Re: Preliminary Evaluation of Sauget Groundwater

Memorandum

To: Tom Heavisides and Todd Rettig, Illinois Department of Natural Resources
cc: Paul Lake, Illinois Environmental Protection Agency
Michelle Ryan, Illinois Environmental Protection Agency
Jim Morgan, Illinois Attorney General's Office
From: Jamie Holmes, Stratus Consulting Inc.
Date: 9/3/2010
Subject: Preliminary evaluation of Sauget groundwater data

Figure 3. Model domain of the TBirdie Consulting groundwater model. It is unlikely that the no-flow boundary to the south is accurate.

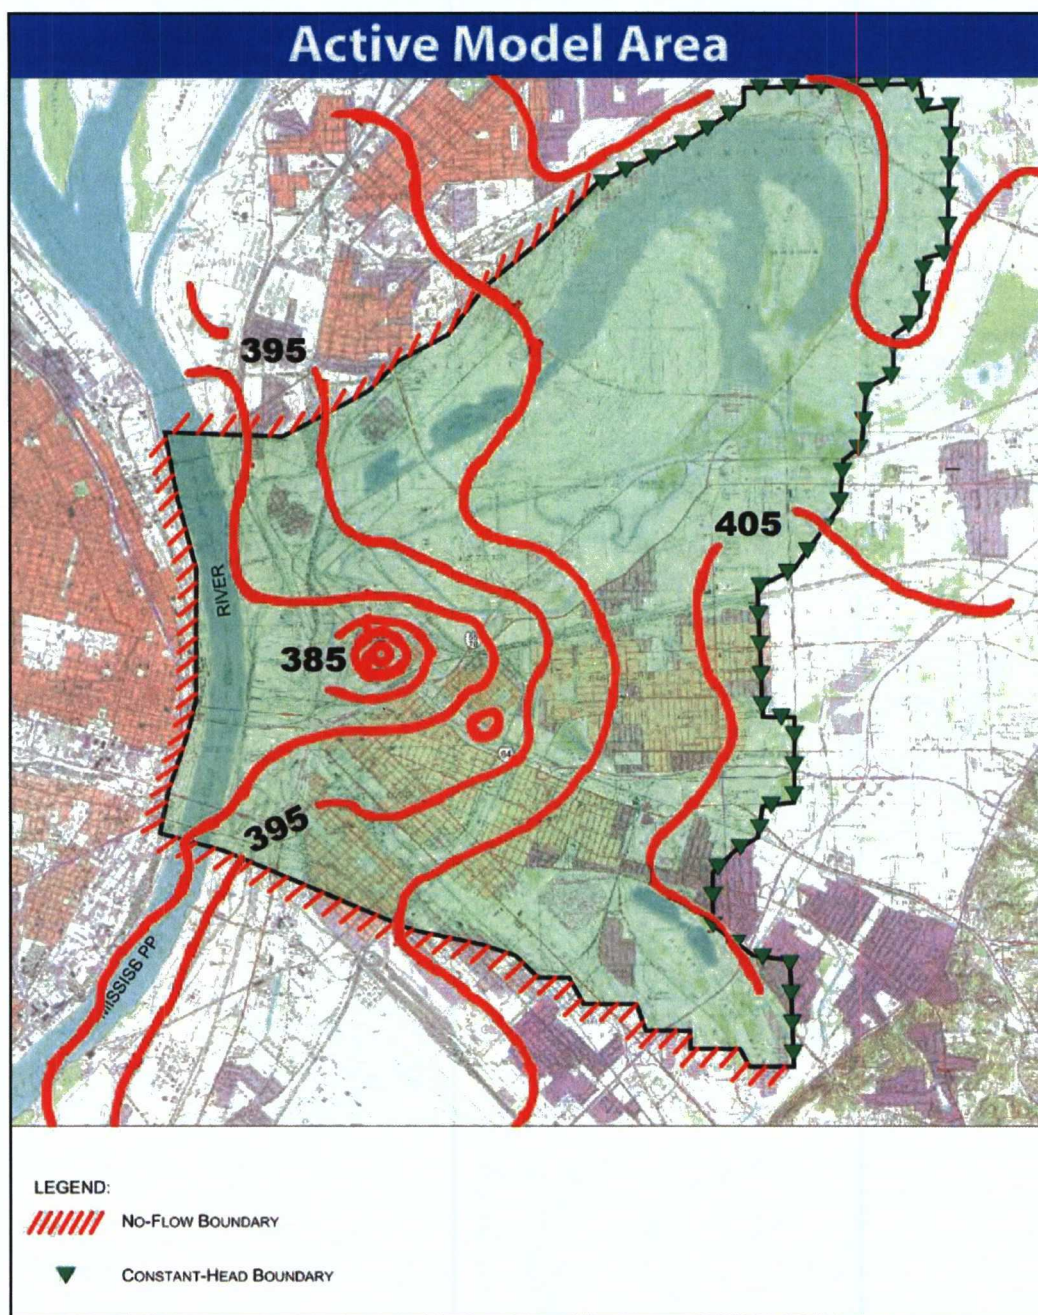
TBirdie Consulting modeled the quantity of water that IDOT will need to pump during a low-probability, large flood event and evaluated whether the existing infrastructure would be capable of pumping that quantity of water. In their model, they set a no-flow boundary on the southern border of East St. Louis (Figure 3). We are not aware of any subsurface features that would prevent alluvial groundwater from flowing across this boundary. In fact, the GSI Environmental (2008) regional flow model (see Section 2) states that the cone of depression from IDOT pumping has extended to Sauget. Thus, it is possible that TBirdie Consulting has underestimated the quantity of water that will flow toward the pumping wells from the south, leading to overestimates of the amount of groundwater drawdown.

In addition, although not directly related to Sauget groundwater contamination, IDOT should consider requesting that TBirdie Consulting re-run their drawdown model, with the southern no-flow boundary placed far enough south that it will not affect the model results. If the model were to show substantial influx of water from south of the current no-flow boundary, additional pumping may be required to maintain water levels below the roadbed, which could subsequently extend the cone of depression farther into contaminated areas at the Sauget site. In addition, the modeled cone of depression could be compared to GSI Environmental model results, which could help to validate each model.

Figure 5. Modeled chlorobenzene plume in the DHU in 2000. The modeled plume indicates transport of chlorobenzene from source areas at W.G. Krummrich ("W.G.K") to the north-northeast, toward the IDOT well field and away from the Mississippi River and the GMCS at Site R.

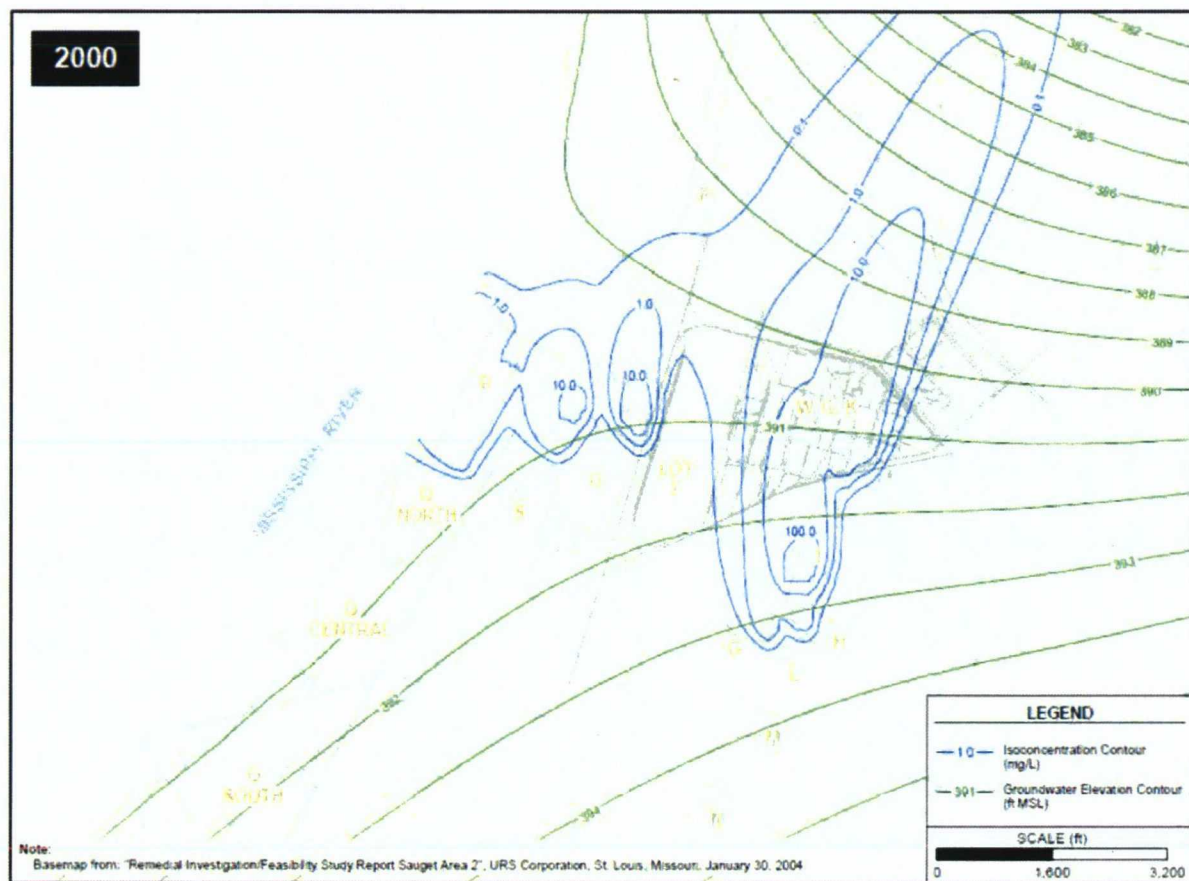
The cone of depression extending to the Sauget site that GSI Environmental (2008) notes in the 1990 potentiometric surface map is evident in their 2000 model runs as well; however, they state that they significantly reduced the highway dewatering system’s flow rate in 2000. Figure 5 shows the GSI Environmental modeled chlorobenzene plume in the deep hydrogeologic unit (DHU) in 2000. Part of this modeled plume is clearly moving to the north-northeast, toward the IDOT well fields and away from the Mississippi River and the GMCS. Because IDOT continues to pump from the highway well fields, at rates substantially higher than were included in this 2000 model run, it is likely that this cone of depression still extends to source areas near the Krummrich plant, and contaminants may still be moving north-northeast rather than west toward the GMCS.

In summary, the GSI Environmental (2008) regional groundwater flow model erroneously assumes that IDOT has been reducing their pumping rates and will terminate pumping entirely in 2010. In years when they assume IDOT is pumping, they show a clear cone of depression extending to W.G. Krummrich, with contaminant transport to the north-northeast. Therefore, contaminants likely continue to migrate in that direction.

- ▶ GSI Environmental should correct their erroneous assumptions about the IDOT highway dewatering system in their regional groundwater flow model, and then re-run their model and estimate the likelihood that IDOT pumping influences will continue to influence contaminant transport at the Sauget site.

Figure 7. Groundwater elevation contours in the DHU in June 2006. Note that north is to the left. There are no data that inform these contours to the north of W.G. Krummrich (“W.G.K”) and northeast of Site P, or to the south of W.G. Krummrich and east of Site Q Central.

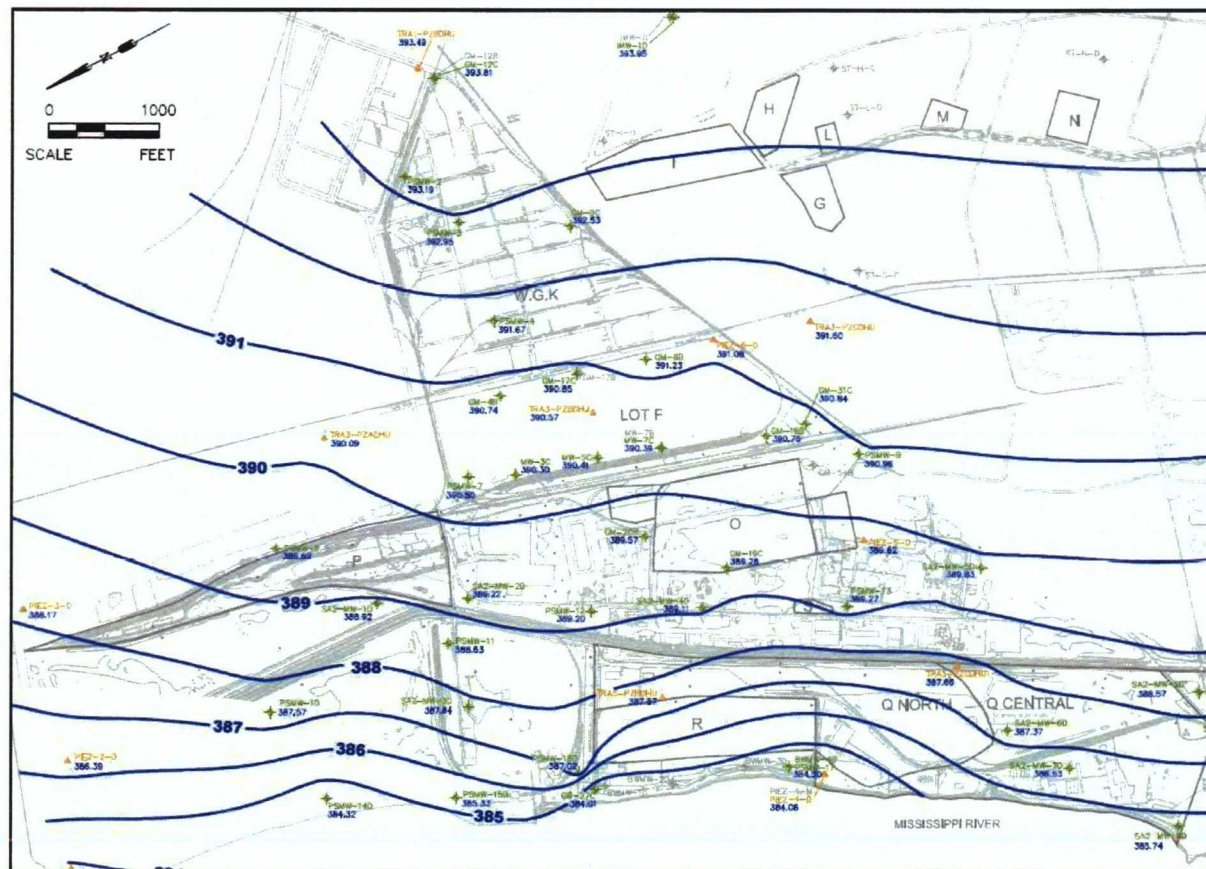
Figure 7 shows the URS (2008) groundwater contours for the DHU. These contours indicate that groundwater flows west toward the Mississippi River and the GMCS at Site R. However, the contours have been extrapolated into areas in which there are no data, including a large area north of W.G. Krummrich and northeast of Site P, and another large area south of W.G. Krummrich and east of Site Q Central. The area north of W.G. Krummich is where GSI Environmental (2008) showed the most influence of IDOT well pumping in their 2000 model run (Figure 5), but the contours are highly uncertain.

Figure 8. Benzene concentrations and modeled isoconcentrations in the DHU, 2005–2006. Note that north is to the left. The data suggest that benzene may not be moving west toward the GMCS along the river at Site R.

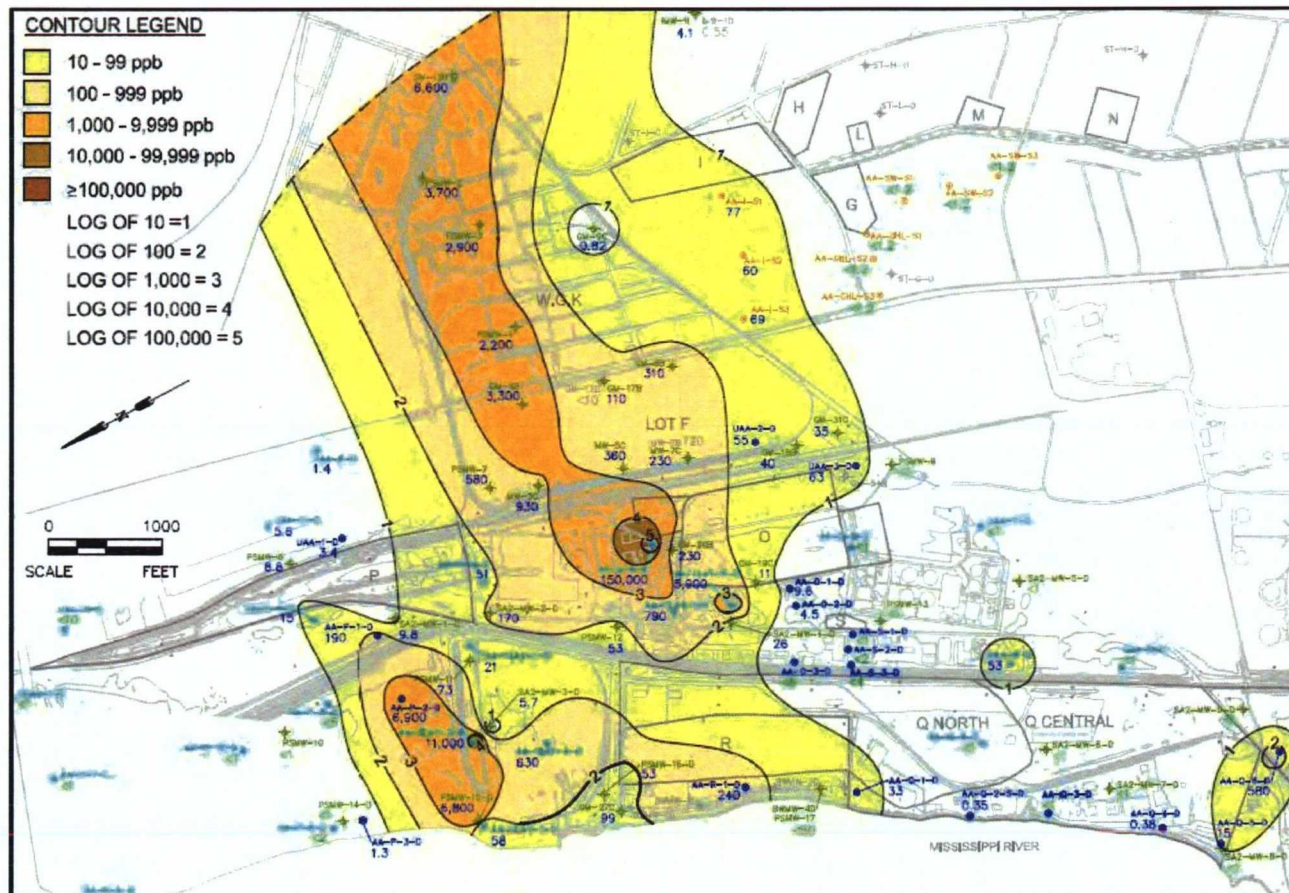
URS (2008) also presents groundwater isoconcentration maps for each contaminant of concern in each hydrogeologic unit (as mentioned previously, these isoconcentration maps are replicated in GSI Environmental, 2009). There are several examples of isoconcentration maps which indicate that contaminant plumes are not flowing west toward the Mississippi River and the Site R GMCS. For instance, benzene in the DHU appears to be moving northeasterly from a source west of W.G. Krummrich (Figure 8). Also, while the bulk of the chlorobenzene in the DHU appears to be moving west from a source at W.G. Krummrich toward the GMCS, chlorobenzene is present at concentrations exceeding drinking water standards in nearly every well to the north and east of source areas (Figures 9 and 10). For both benzene and chlorobenzene, there are no clean wells to the north or northeast that can be used to delineate the extent of the plume (in fact, there are almost no wells at all to the north or northeast). The plume, as depicted, is arbitrarily cut off with dotted lines near the boundary of the Sauget site (Figures 8 and 9). The locations of the northernmost contaminated wells at the Sauget site in relation to source areas near W.G. Krummrich, the GMCS at Site R, and the IDOT well fields (Figure 10) again strongly suggest north-northeastward contaminant transport. The lack of wells in this area is a substantial groundwater data gap.

Figure 9. Chlorobenzene concentrations and modeled isoconcentrations in the DHU, 2005–2006. Note that north is to the left. Chlorobenzene is widespread to the north of the source areas, where few wells are available for assessing plume extent.

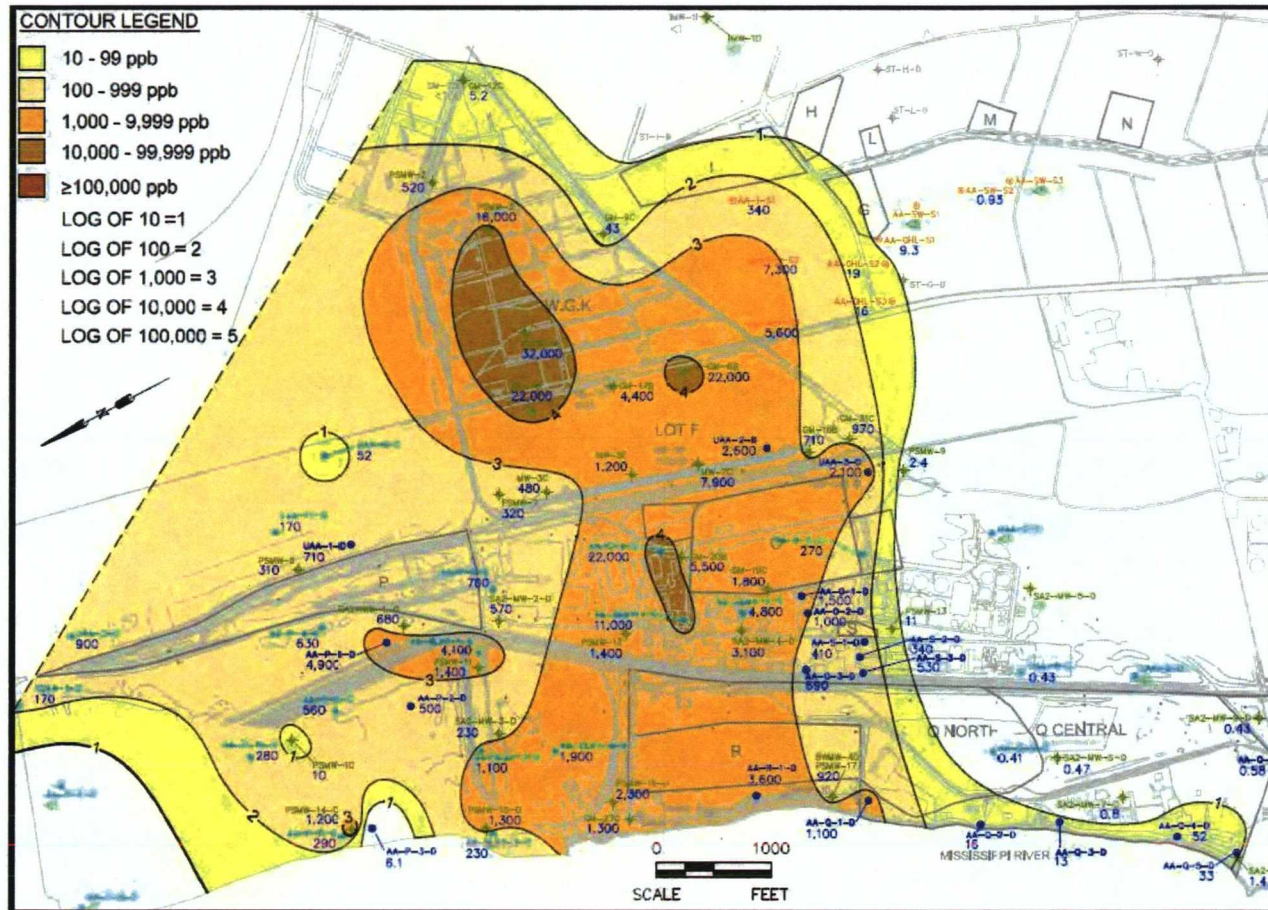
The modeled chlorobenzene plume in the DHU calibrated to 2005/2006 contaminant data does not correspond well with measured chlorobenzene concentrations at the north end of the Sauget site. Several wells north of the 0.1 mg/L contour have chlorobenzene concentrations that exceed 0.1 mg/L, including 0.9 mg/L near the north end of Site P (Figure 6). The model thus appears to underestimate the north-northeastward progression of the plume.

Figure 11. Benzene concentrations and modeled isoconcentrations in the SHU, 2005–2006. Note that north is to the left. The extent of benzene contamination, particularly to the east and southeast, cannot be adequately determined given the well coverage.

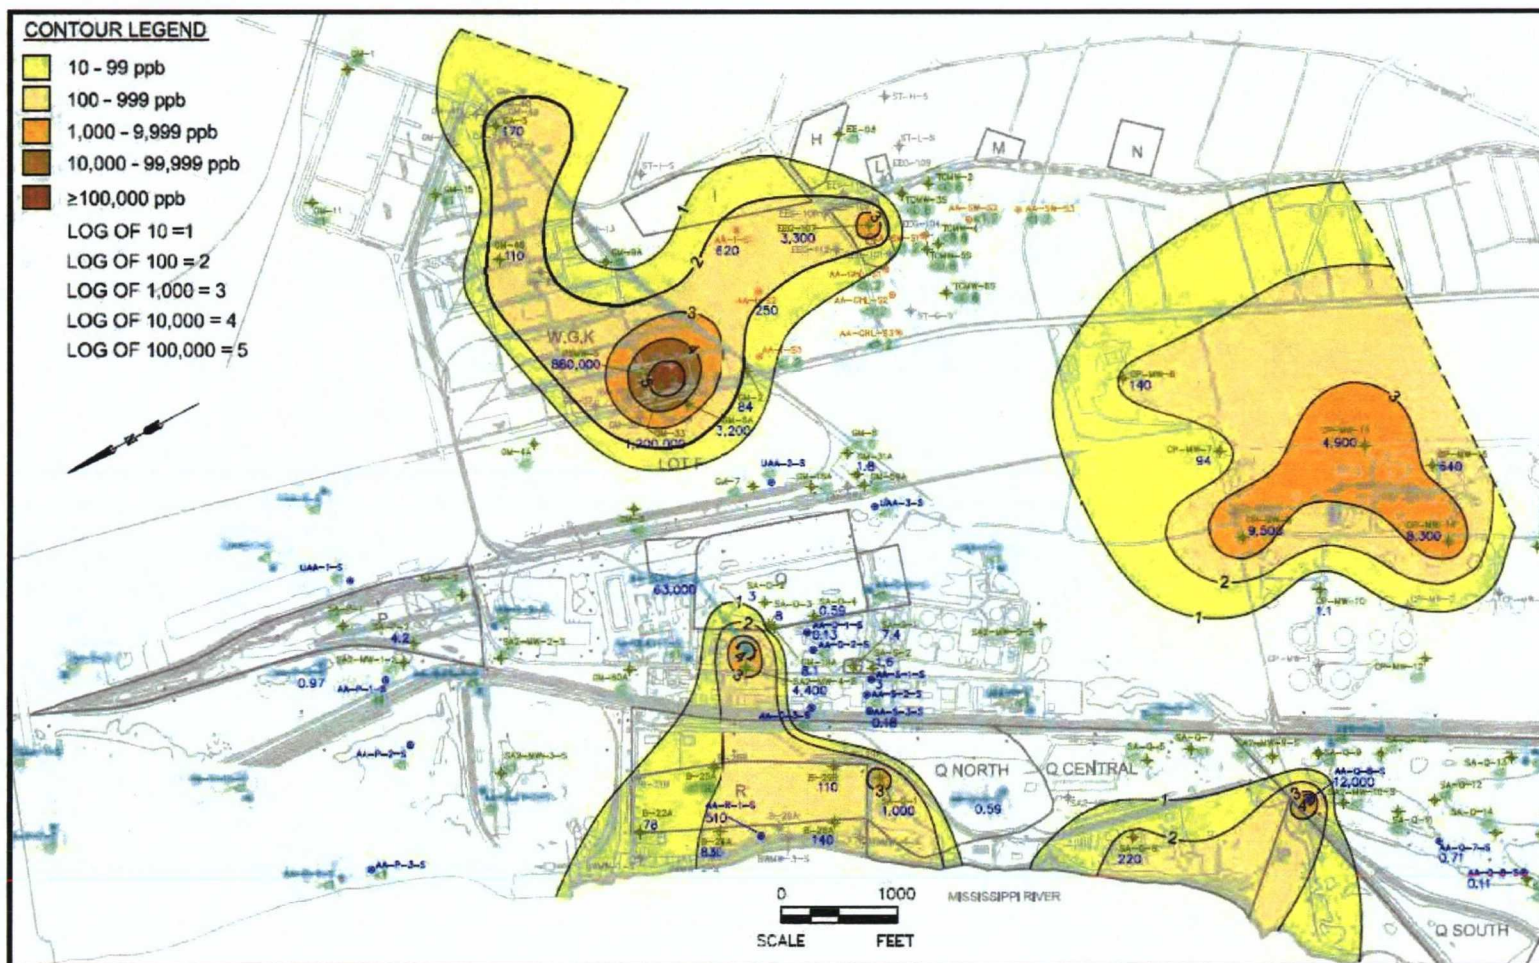
Similar data gaps are apparent south and east of the W.G. Krummrich plant. For example, the isoconcentrations of benzene in the shallow hydrogeologic unit (SHU) end with an arbitrary dashed line near the eastern boundary of the W.G. Krummrich plant, with no clean wells to confine the plume boundary (Figure 11). In addition, a plume southwest of W.G. Krummrich and southeast of Site Q Central has been depicted based on data from few wells, and includes no clean wells to the east or southeast (Figure 11). Benzene contamination is found northeast of the apparent source, which suggests that the plume may not be moving toward the Mississippi River.

- ▶ An expanded well network should be established and included in quarterly groundwater sampling for both water elevation and chemical analysis. Wells are particularly deficient to the north, northeast, and east of the W.G. Krummrich plant, as well as east and south of Area 1 (see Figures 10 and 11). The monitored well network should include uncontaminated wells surrounding all Sauget plumes, allowing constraint of plume size estimates and establishment of sentinel wells for determining plume progression.

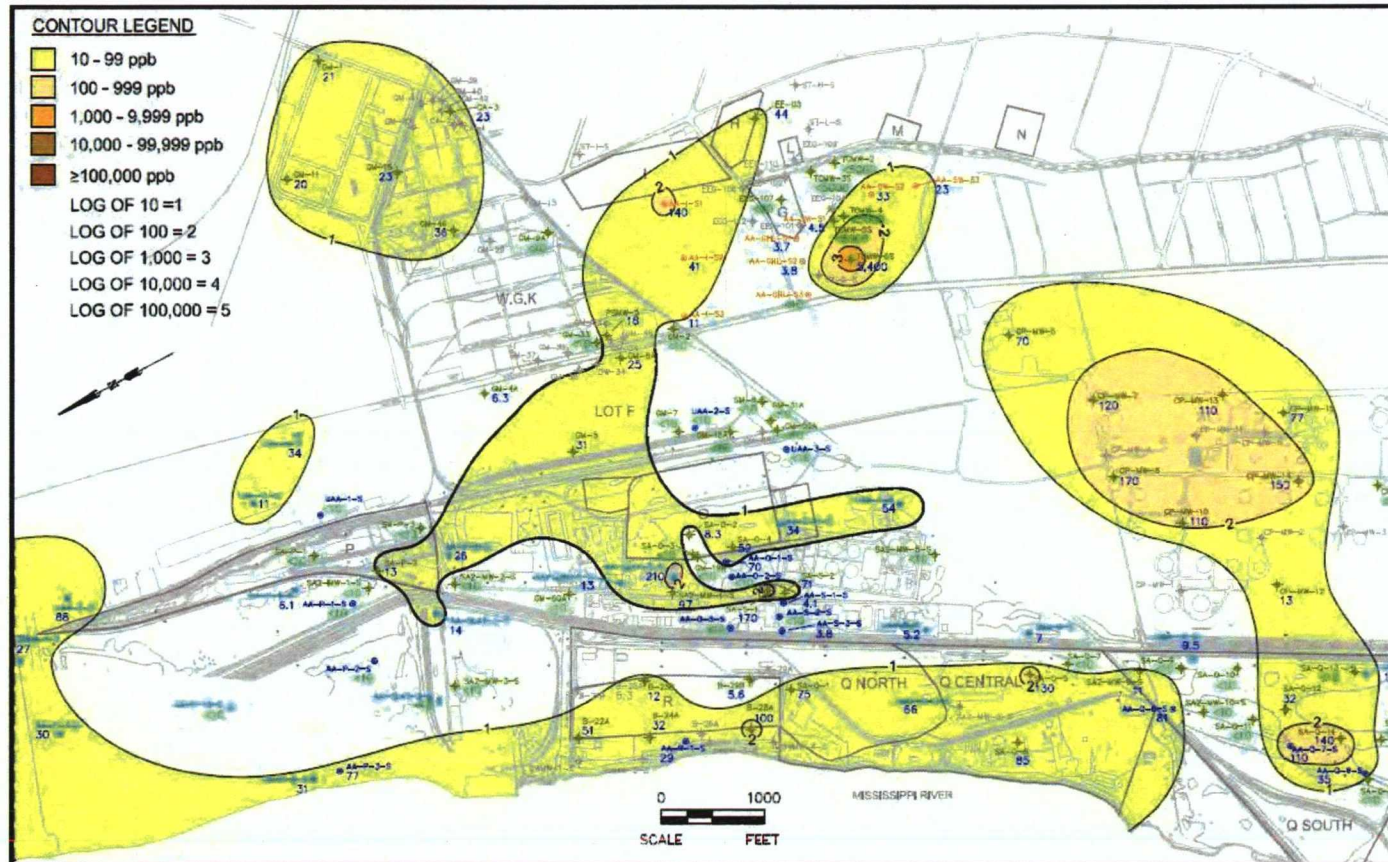
In addition to the benzene and chlorobenzene data gaps in Sauget site groundwater, we note that arsenic concentrations in groundwater exceed the 10 µg/L Federal drinking water standard over a broad area of the site and adjacent to the site. The U.S. Geological Survey (Warner et al., 2003) suggests that background arsenic concentrations in this part of Illinois should be less than 5 µg/L. Arsenic waste was landfilled at Sauget, and the arsenic isoconcentration map in the SHU shows areas of higher concentrations that may correspond to source areas (Figure 12). However, arsenic concentrations in the SHU (as well as in the other hydrogeologic units) are also elevated above drinking water standards along the Mississippi River north of the Sauget site, and northeast of the Sauget site (Figure 12). The sources of arsenic north of the site are not clear, and the extent of the arsenic plume to the north and northeast cannot be established with the existing well network.

- ▶ An analysis of the sources, fate, and transport of arsenic in the Sauget/East St. Louis area should be conducted to ascertain the extent of arsenic contamination and determine whether additional remediation is required to address the contamination.
